# MEMO

**To:** Kristopher Byrd, Well Construction and Compliance Section Manager  
**From:** Joel Jeffrey, Well Construction Program Coordinator  
**Subject:** Review of Limited License Application LL-1799  
**Date:** December 12, 2019

# Groundwater Application Review Summary Form

Application # **G- 12-1799**

### Water Levels in Nearby Wells Accessing Columbia River Basalt Aquifers

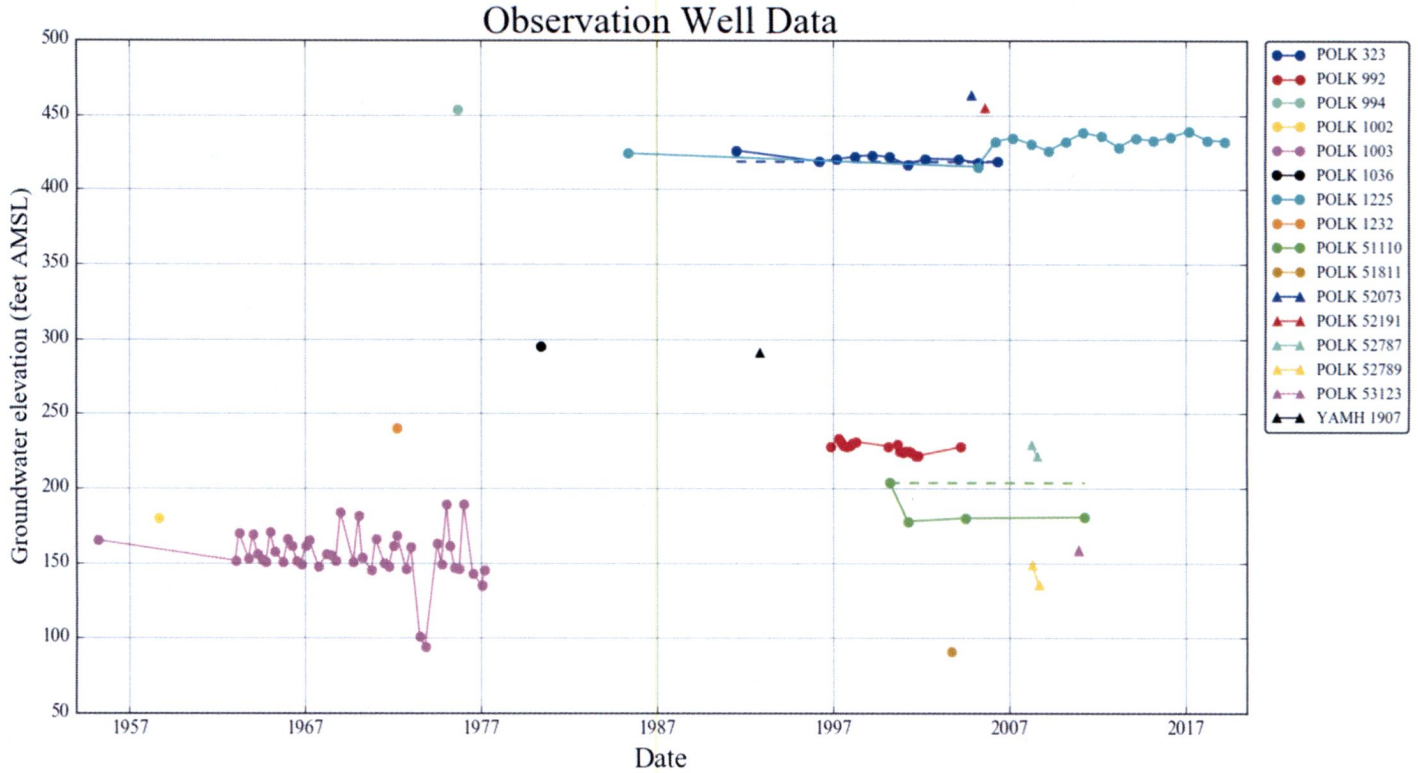
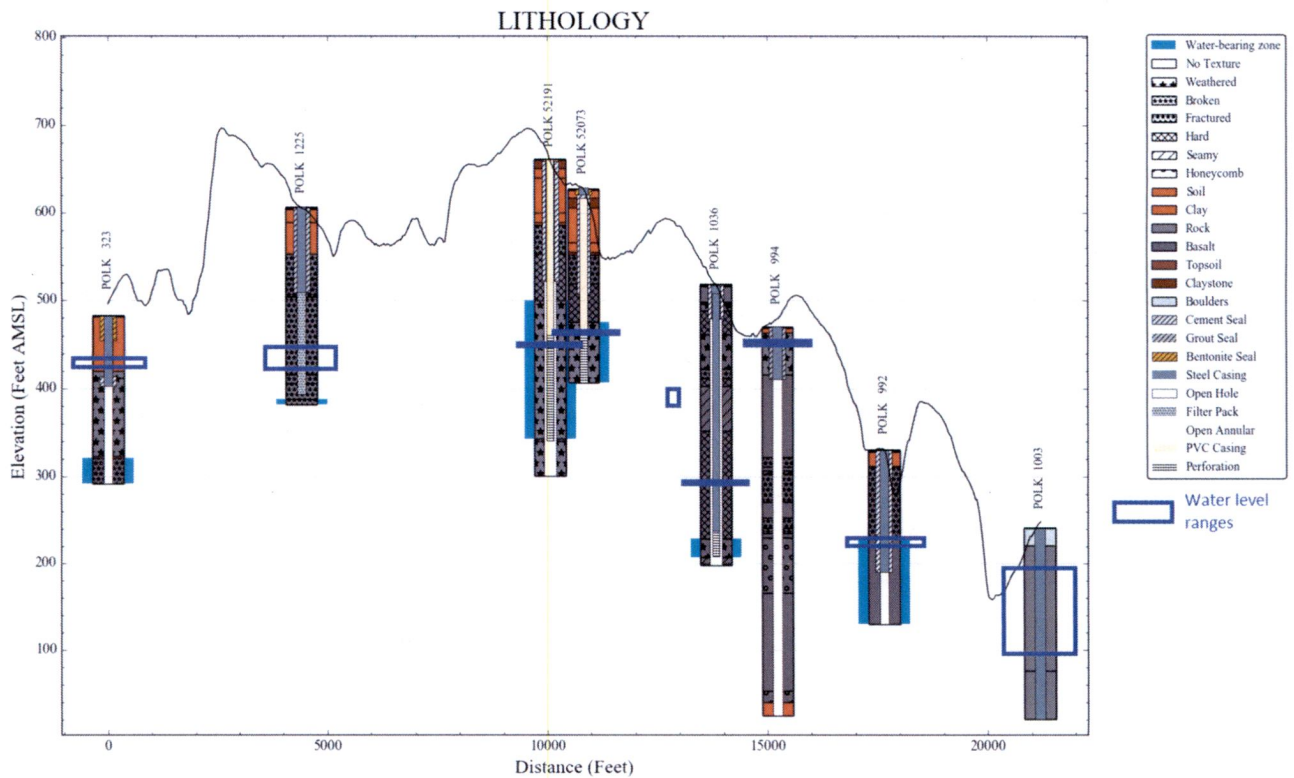
The proposed POA, POLK 1036, is located in the southeastern foothills of the Eola Hills, which are comprised of Columbia River Basalt Group (CRBG) flows overlying older marine sedimentary rocks. Groundwater data for the CRBG aquifers in this area is sparse, with wells completed in the CRBG showing low to moderate yields from ~5-50 gpm. The long-term datasets for wells accessing CRBG aquifers in the vicinity show relatively stable levels. However, the elevation separation between the water levels in those wells vs. POLK 1036 makes it difficult to establish whether they access the same CRBG aquifer and conclude whether groundwater will be available within the capacity of the resource.
